NEW YORK CITY DEPARTMENT OF CORRECTION

**ADDENDUM #4 PIN 072202009CPD**

**George R. Vierno Center (GRVC) State of Good Repair**

**DESCRIPTION OF CHANGES**

DRAWING NO.

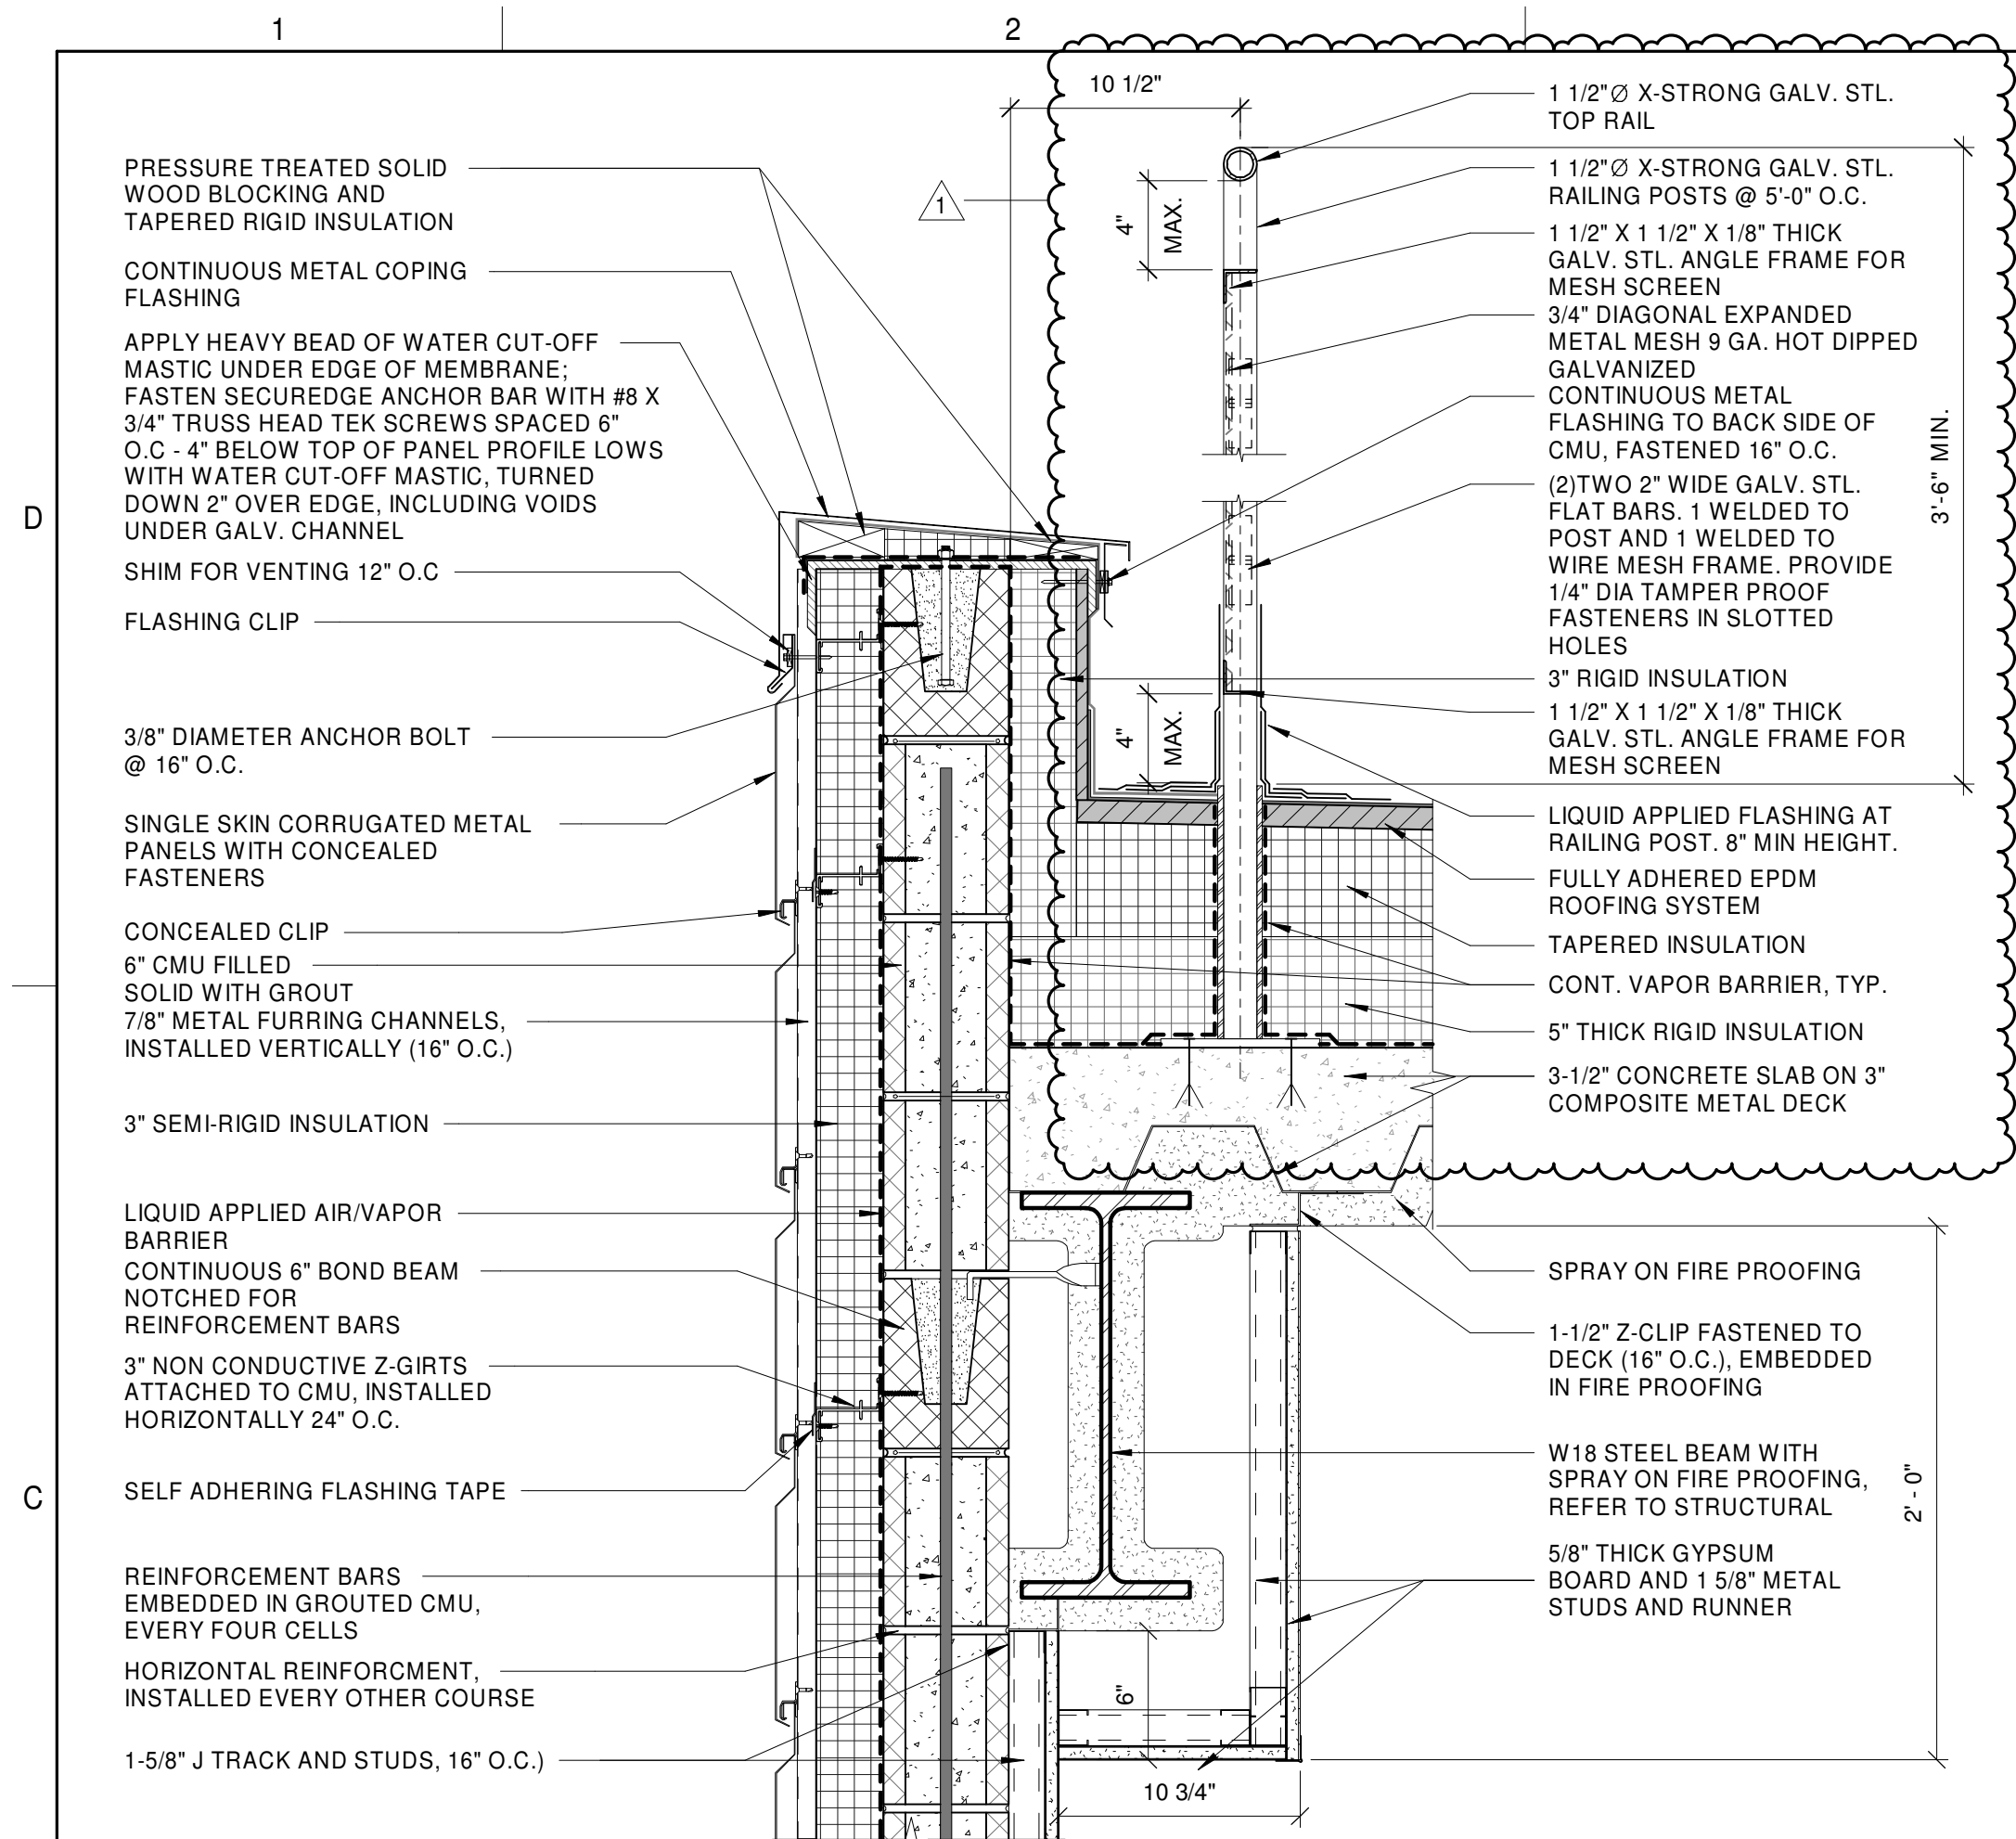
1. **A-301.00:** Added Mesh Infill Panels at the Roof Guardrail on the Elevations.
2. **A-304.00:** Added Mesh Infill Panels at the Roof Guardrail on the Wall Sections.

**A-320.00**

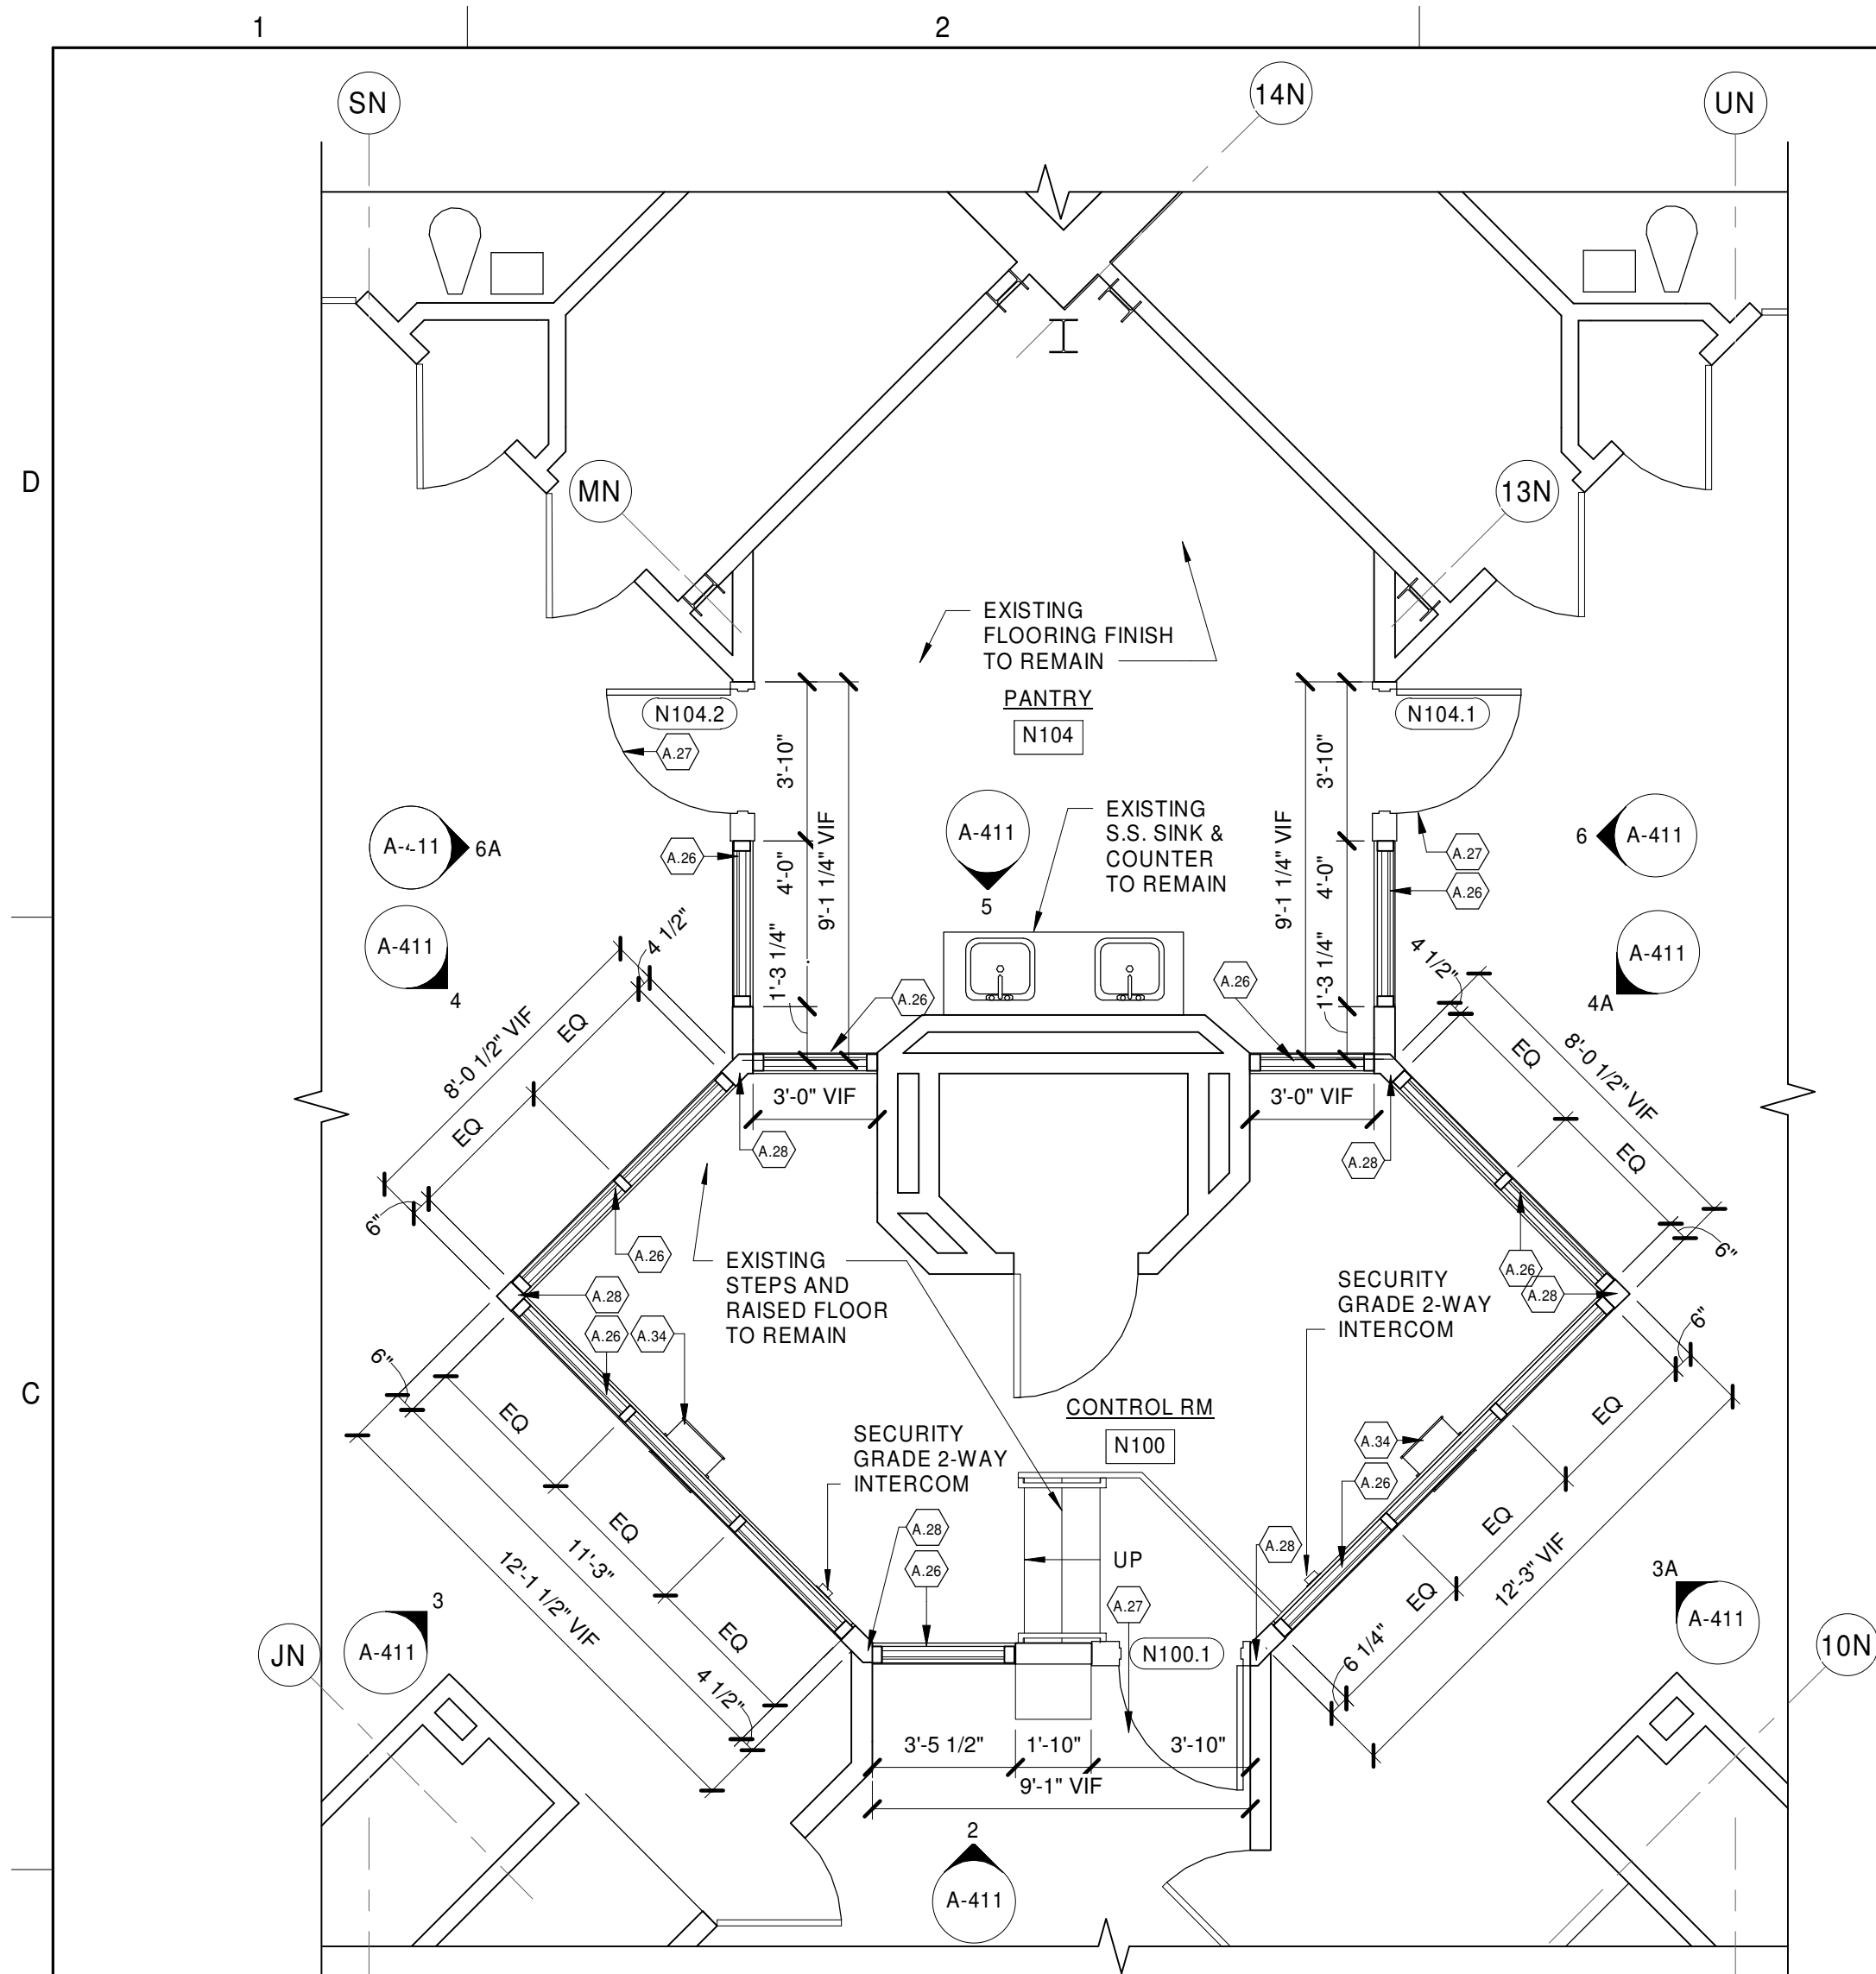
3. **A-320.00:** Added Mesh Infill Panels at the Roof Guardrail on the Parapet Sections.
4. **A-411.00:** Revised Keynote #A.26.
5. **A-412.00:** Revised Keynote #A.26.
